Technical Memorandum

Title	Murdoch Drive Connection - Roundabout Analysis		
Client	City of Cockburn	Project No	CW1004500
Date	Prepared 17/10/2017	Status	Rev A
Author	Andrew Barry	Discipline	Civil Infrastructure and Property
Reviewer	Andreas Want	Office	Perth

RE: Murdoch Drive Cardno Assessment of MRWA Option 4

Roundabout 1 - Murdoch Drive / Farrington Road / Allendale Entrance

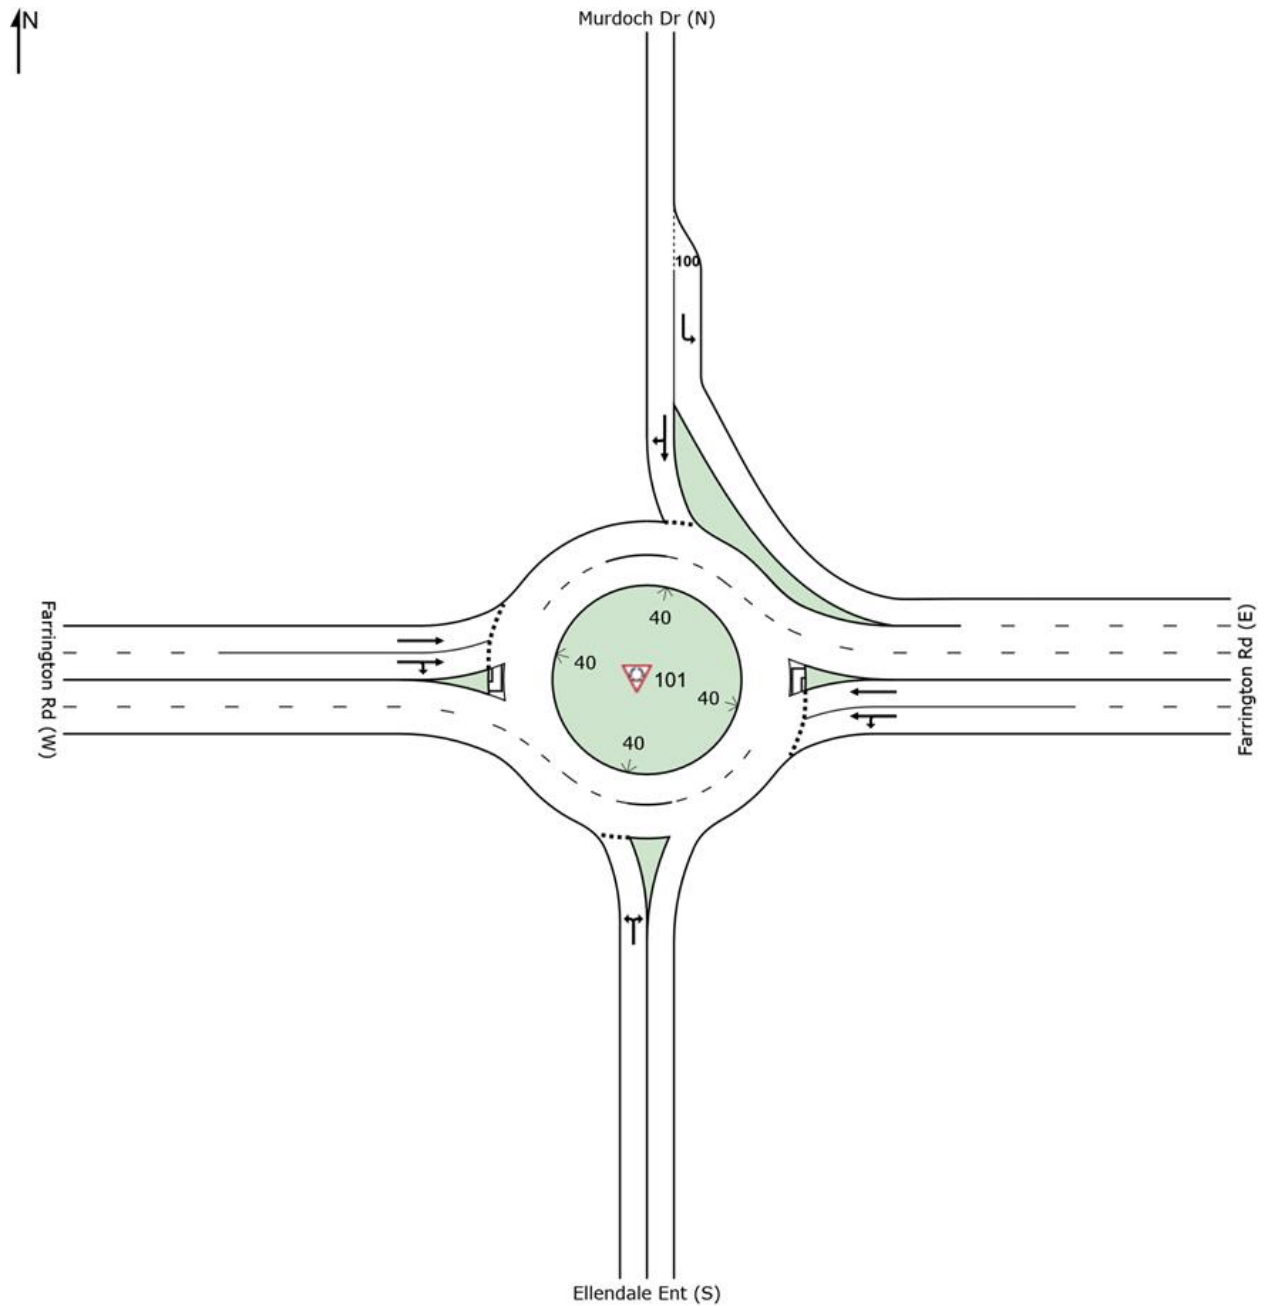
For the Murdoch Drive / Farrington Road / Allendale Entrance roundabout, the Sidra analysis shows that this roundabout will operate with acceptable Level of Service (LOS) for all scenarios.

Roundabout 2 - Bibra Drive / Murdoch Drive Connection

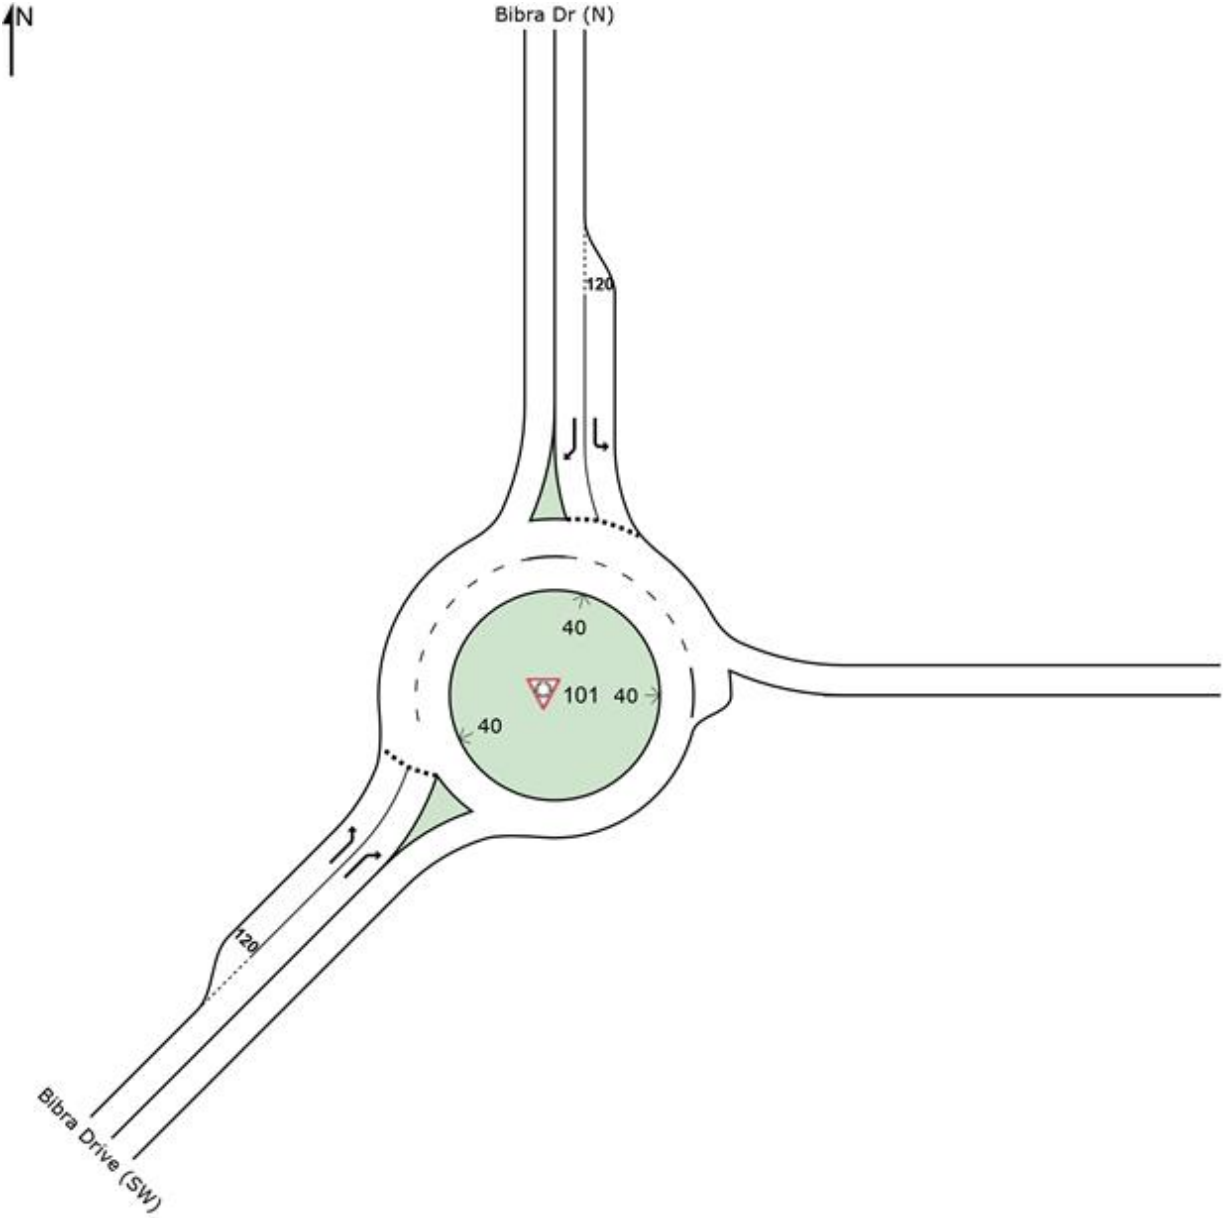
For the Bibra Drive / Hope Road roundabout, the analysis shows that this will operate with acceptable LOS for the 2021 scenarios, noting that the eastern approach is operating with higher-than-desired Degree of Saturation (DOS) for the 2021 PM scenario. However, for the 2031 PM scenario, the forecast growth in southbound traffic on Bibra Drive will not provide sufficient gaps in traffic for the eastern approach, resulting in queue lengths extending back to Roe Highway and a LOS of F.

Noting the low level of service provided by the current MRWA design, Cardno undertook further analysis on the Bibra Drive / Murdoch Drive Connection roundabout factoring improvements for the southbound approach and exit. This is represented graphically in the Sidra layout below.

Roundabout 2 - Bibra Drive / Murdoch Drive Connection (Cardno Amended Geometric Design)

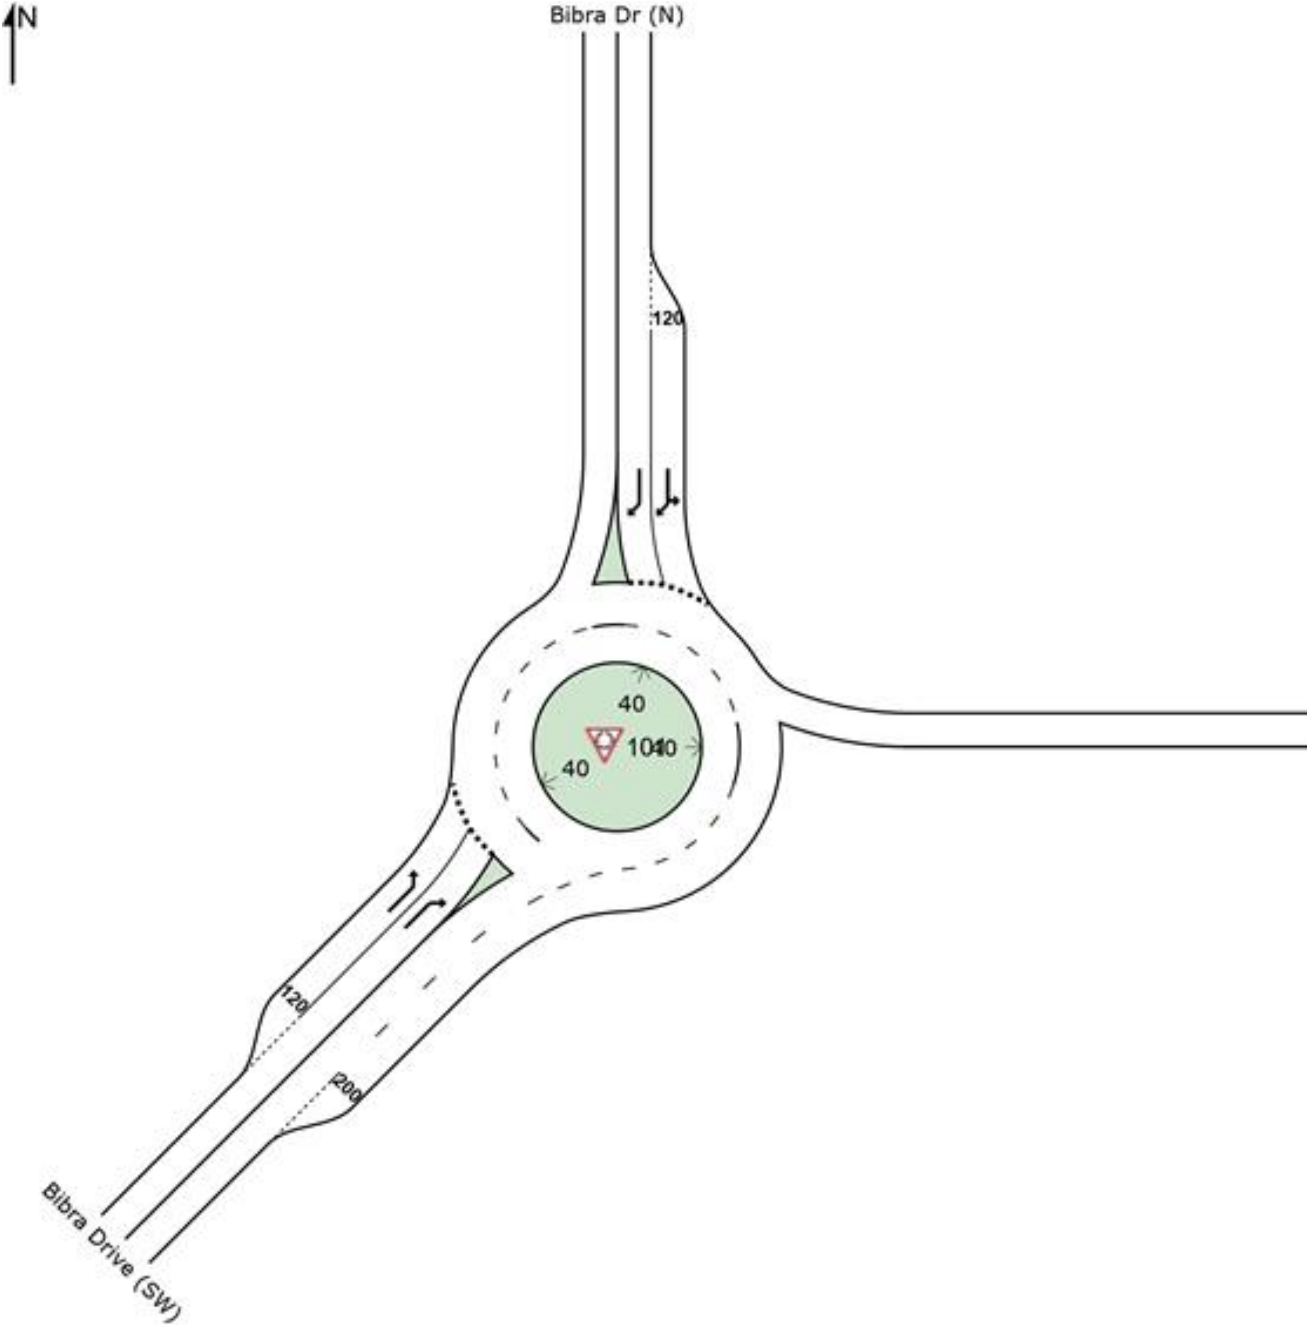
The proposed improved design for the southbound approach and exit has resulted in an overall satisfactory performance.
